Burlington Development Review Board

BURLINGTON DEVELOPMENT REVIEW BOARD

MEMORANDUM

To: Development Review Board
From: Mary O'Neil, AICP, Principal Planner
Date: ~~April 21, 2020~~ June 16, 2020
RE: ZP20-0773CU, 10 Baird Street

SCALE: 1" = 20' HOR.
1" = 20' VERT.

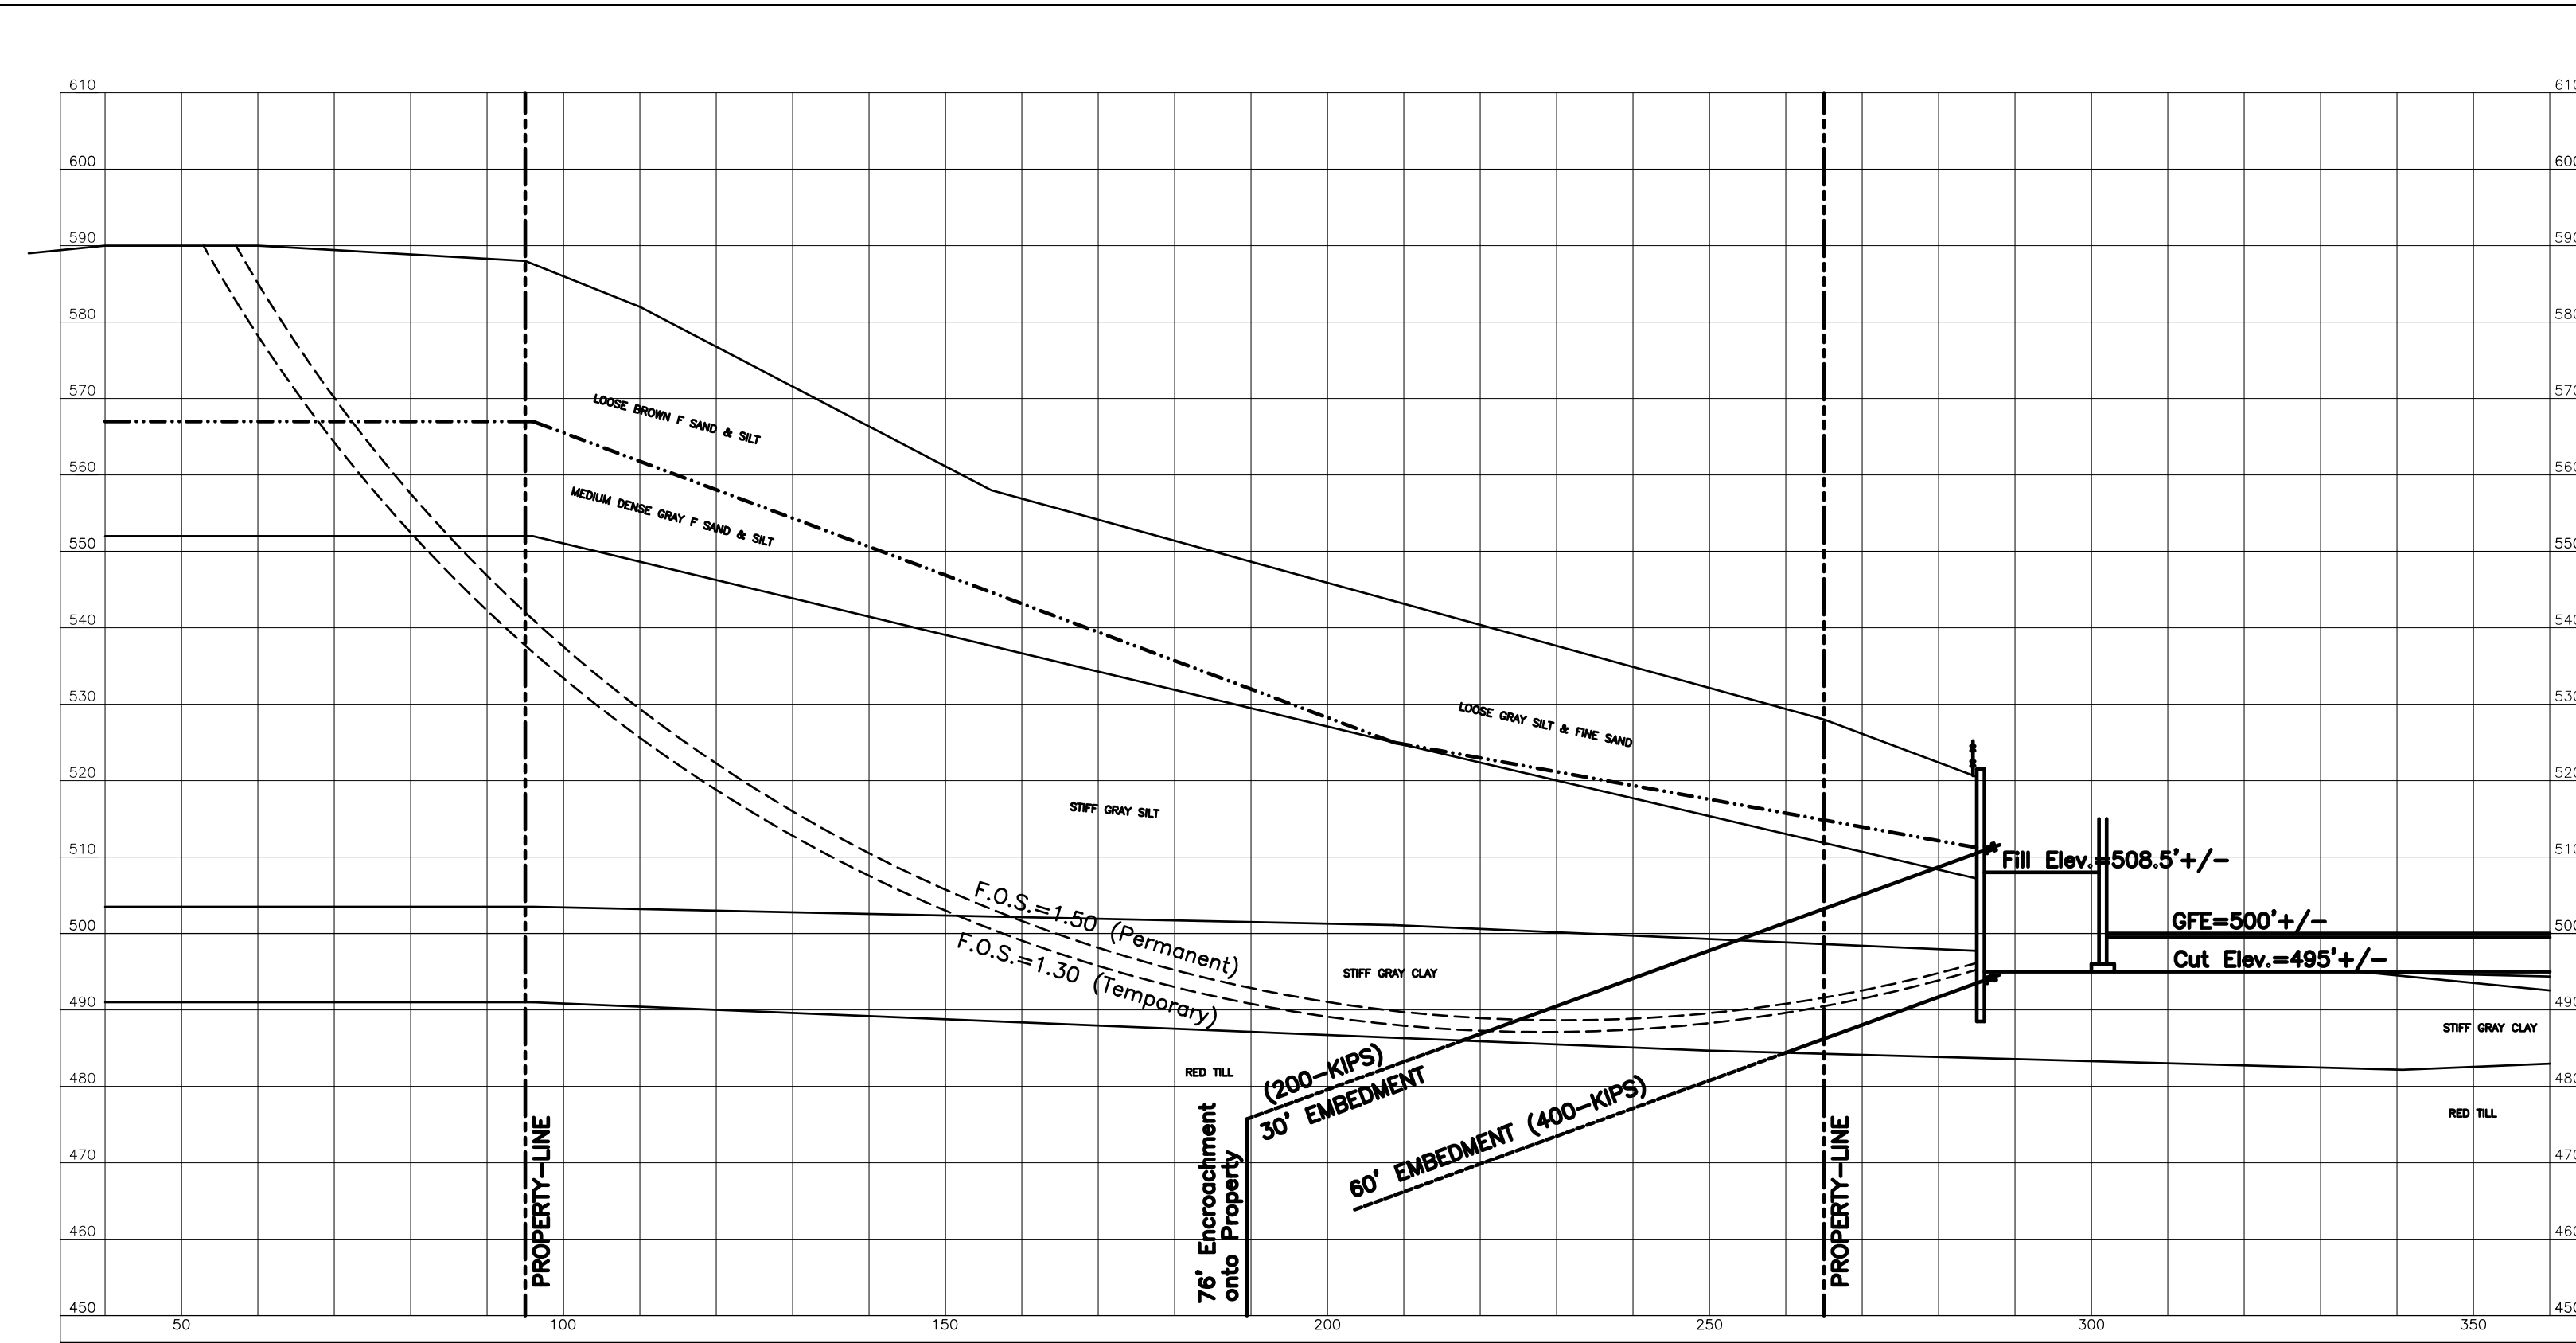
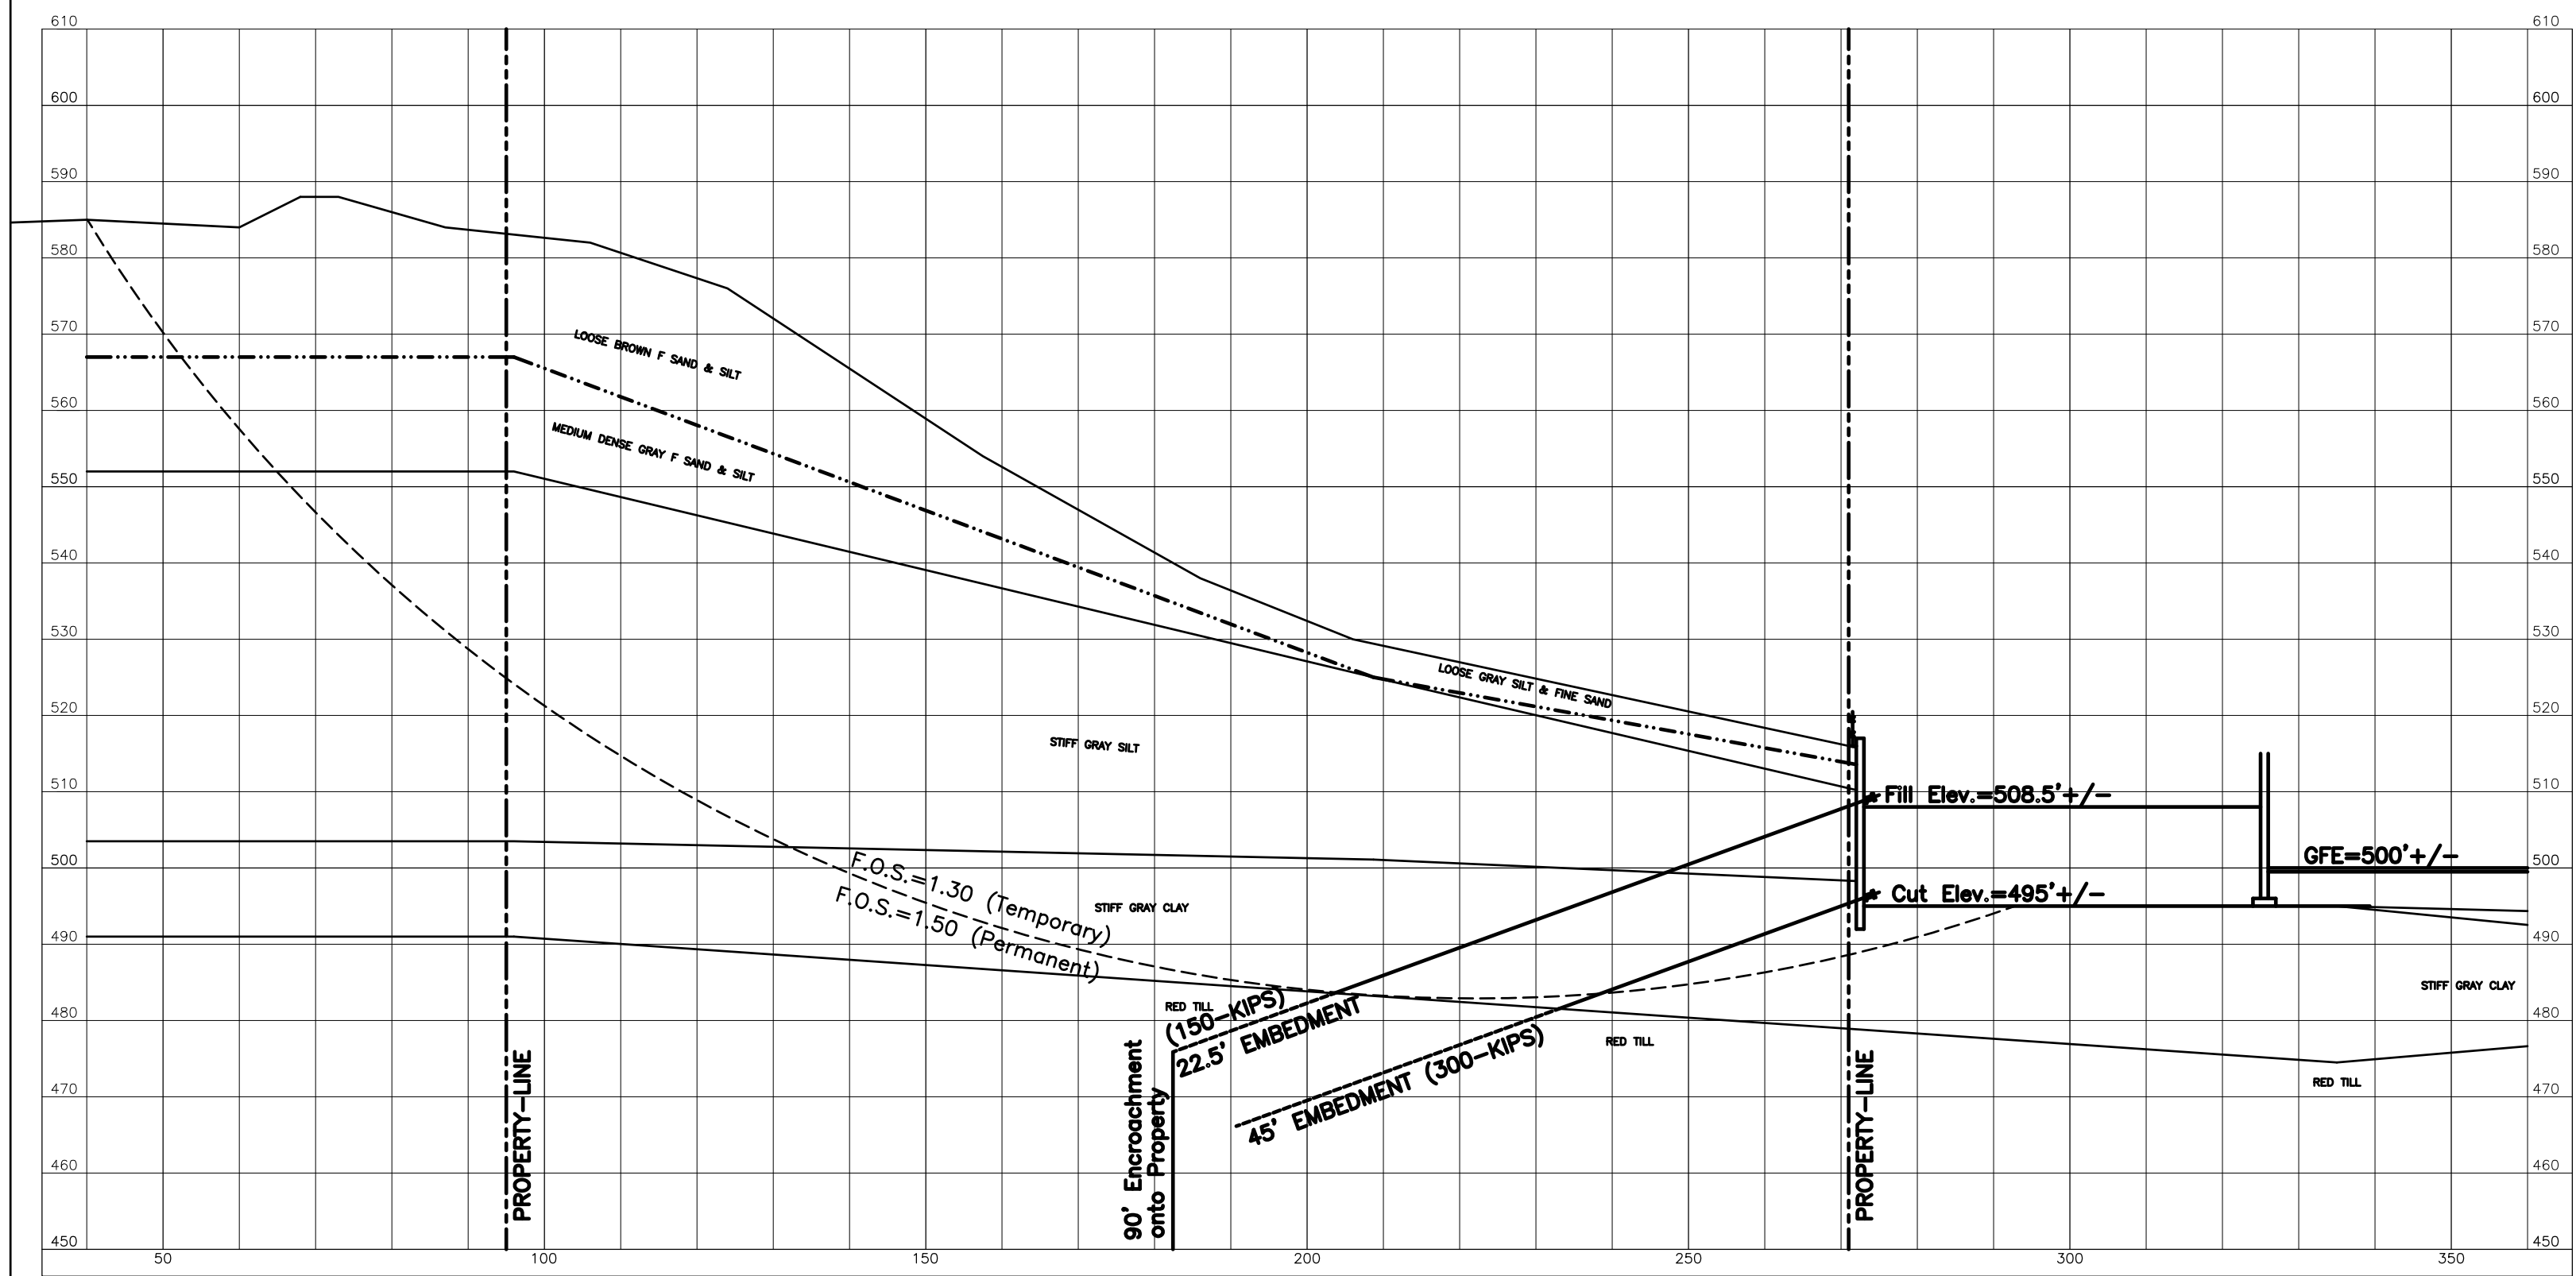
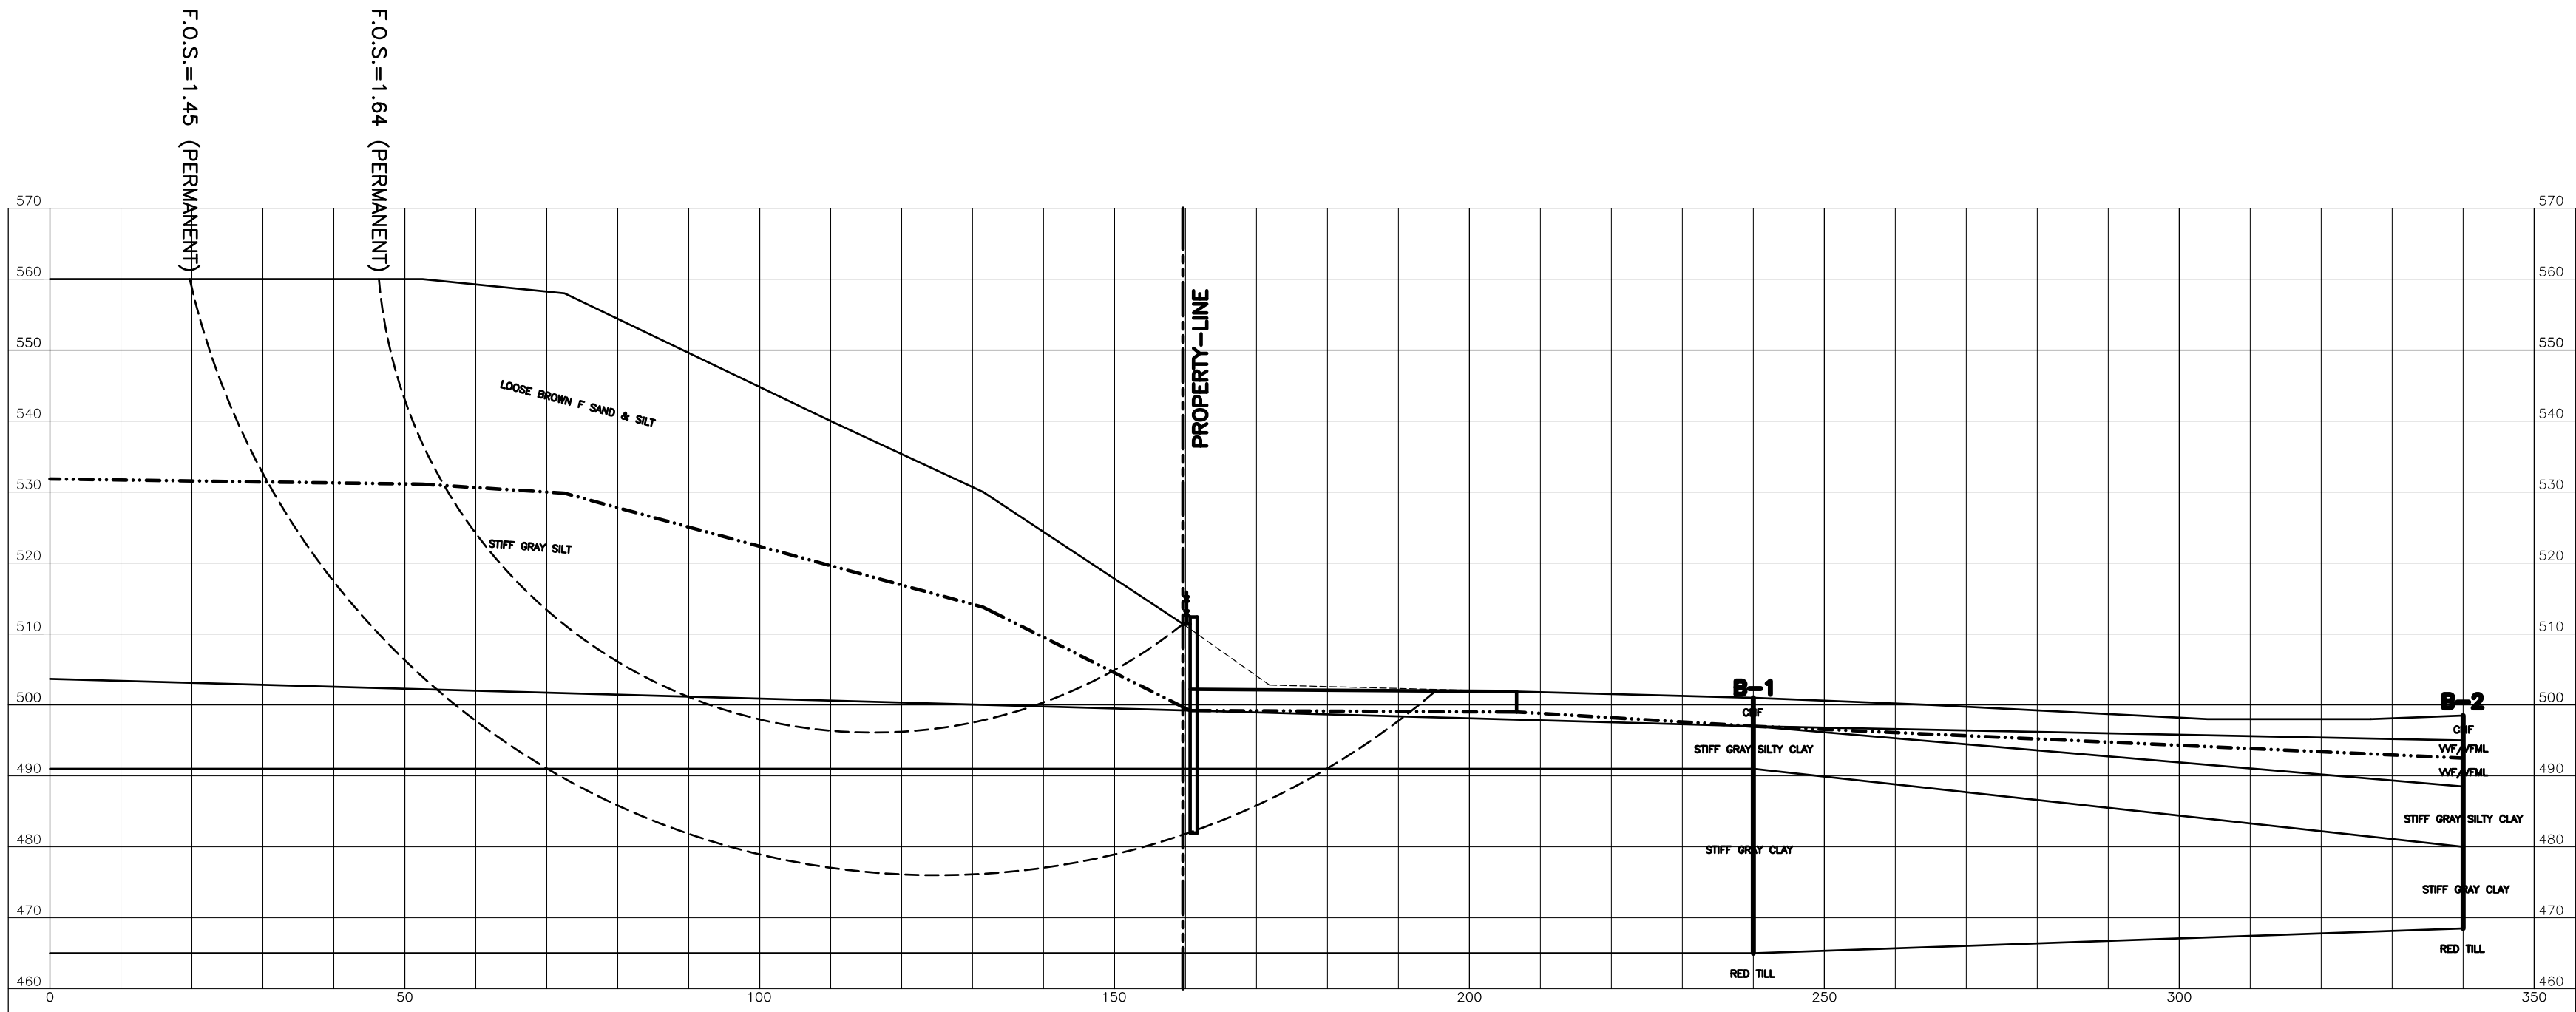
As required, geotechnical details have been provided as to the proposed retaining walls behind the building. Significant cut into the bank is proposed. Sheet piling will hold back the bank to allow space for the building and related parking. Site plan details, elevations, cross sections, and anchoring details have been provided. All have been provided by a Vermont licensed engineer. The City Engineer has reviewed the shoring plans and has identified only one remaining issue as to property rights to install and maintain the retaining wall system with neighboring properties. A draft easement with the adjoining property for anchoring and maintaining the proposed retaining wall has been submitted for review. The applicant requests that execution of the easement be a condition of approval. **Affirmative finding as conditioned.**
